Access Compliance Report Public Rights-of-Way (Curb Ramps)

Intersection ID: 49946 Main Street: OPEN_BOOK_LN Cross Street: KUYKENDALL_RD Location: SW

ADA ID: 6CFA704176C3 Ramp Type: BlendTrans1 Initial Pass/Fail: Fail Overall Compliance: No Severity Score: 1.25

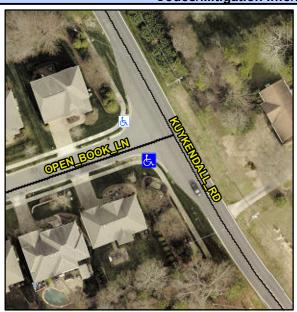
Not Found, R304.5.3

Field Measurements/Component Compliance					
Comp	liance Description	Data	Comp	liance Description	Data
N/A	Ramp Length (in)	37.0	Yes	BlendTrans Slope (%)	3.6
Yes	Ramp Width (in)	48.0	No	BlendTrans XSlope (%)	3.0
N/A	Flare Type LT	N/A	N/A	Flare Type RT	N/A
N/A	Flare Slope LT (%)	N/A	N/A	Flare Slope RT (%)	N/A
N/A	Flare Traversable LT?	N/A	N/A	Flare Traversable RT?	N/A
N/A	Landing Length (in)	N/A	N/A	DWS Provided?	N/A
N/A	Landing Width (in)	N/A	N/A	DWS Contrast?	N/A
N/A	Landing Slope (%)	N/A	N/A	DWS Length (in)	N/A
N/A	Landing X Slope (%)	N/A	N/A	DWS Full Width?	N/A
N/A	Landing Curb? (Y/N)	N/A	N/A	DWS Offset (in)	N/A
N/A	Shared Landing?	N/A			
N/A	Gutter Ponding?	N/A	N/A	Gutter Slope (%)	N/A
N/A	Gutter Lip Ht (in)	N/A	N/A	Gutter X Slope (%)	N/A
N/A	Painted X Walk1?	No	N/A	Painted X Walk2?	N/A
	X Walk 1 Direction	To NW		X Walk 2 Direction	N/A
	X Walk 1 Width (in)	N/A		X Walk 2 Width (in)	N/A
	X Walk 1 Slope (%)	1.0		X Walk 2 Slope (%)	N/A

Remove & Replace Curb Ramp With Two New Directional Ramps or Equivalent.
